DEVELOPMENT REVIEW BOARD REPORT

SUBJECT	DC Ranch Parcel 1.12 8-PP-2004 & 36-DR-2004
REQUEST	<p>Request to approve preliminary plat, site plan & elevations for a 38-townhome development on 10+/- acres.</p> <p>Key Items for Consideration:</p> <ul style="list-style-type: none">• This is a new development/subdivision in DC Ranch's Planning Unit 1.• The development will comply with the Master Plans for Planning Unit 1.• This development is located in the Airport Influence Area. <p>Related Policies, References: 54-ZN-1989#1 thru 8, 5-MP-2002, Community Facilities District</p>
OWNER	Artisan Homes 602-277-5638
APPLICANT CONTACT	Landmark Engineering 602-861-2005
LOCATION	17800 N 94th St
BACKGROUND	<p>Zoning. DC Ranch is a master planned community. The site is zoned Single Family Residential District/Planned Community District (R1-7/PCD). Per the master development plan, the R1-7/PCD zoning district allows for 5,000-square-foot, or larger, residential lot sizes as well as townhomes.</p> <p>Context. Planning Unit 1 of DC Ranch is generally located between Pima Road to the west and 94th Street to the east, and between Union Hills Road to the north and Bell Road to the south. Planning Unit 1 i

DC RANCH PARCEL 1.12 PRELIMINARY PLAT

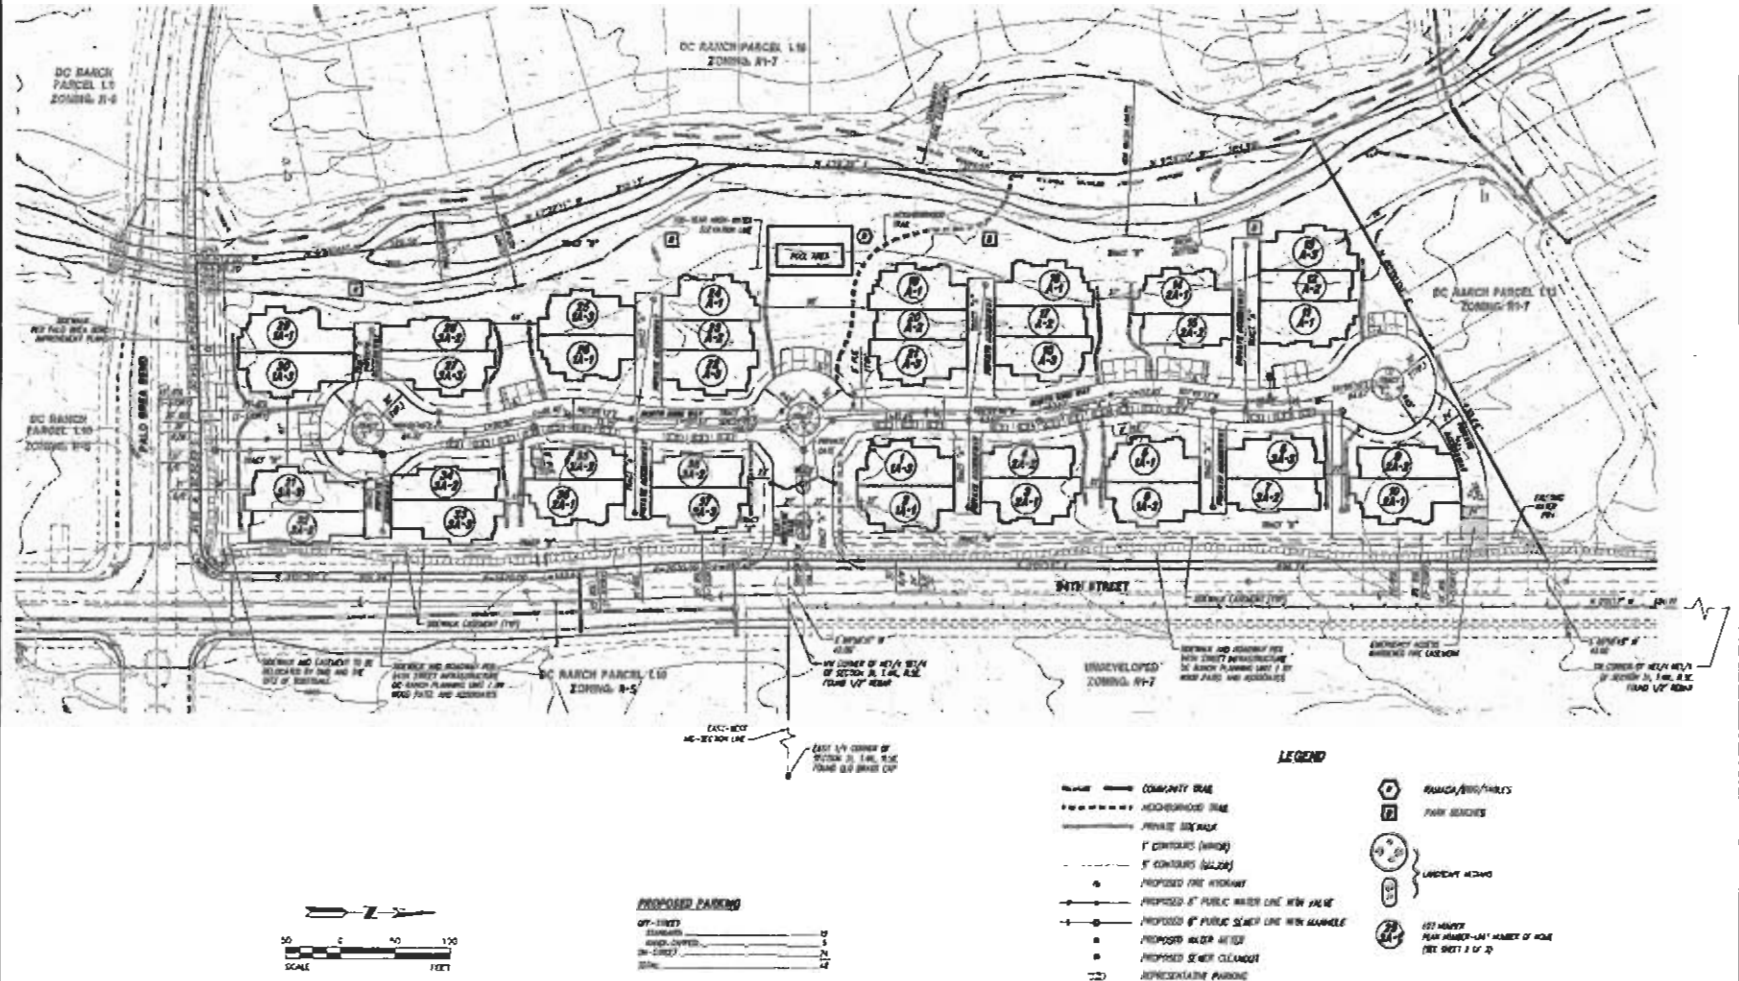
11. The preliminary plat shows improvements within the 100-year floodplain for the wash located west of this parcel. Final plans staff may require a backwater analysis as part of the final drainage report to assess the magnitude of the impacts to the existing 100-year floodplain and water surface elevations and mitigation for these impacts may be required.

12. Lots 13, 14, 18, 22, 28, and 29 are in close proximity to the wash located west of this site. The final drainage report shall provide an analysis of the potential for erosion/meandering of this wash. Mitigation for potential erosion shall be provided if warranted based on the results of the analysis.

13. The preliminary plat shows a portion of lot 32 within the existing sidewalk easement for 94th Street. The applicant will need to apply for a release of the affected portion of the easement from the City of Scottsdale. If the release of easement is not granted, the configuration of lots will need to be revised so that no portion of lot is within the easement or the lot removed.
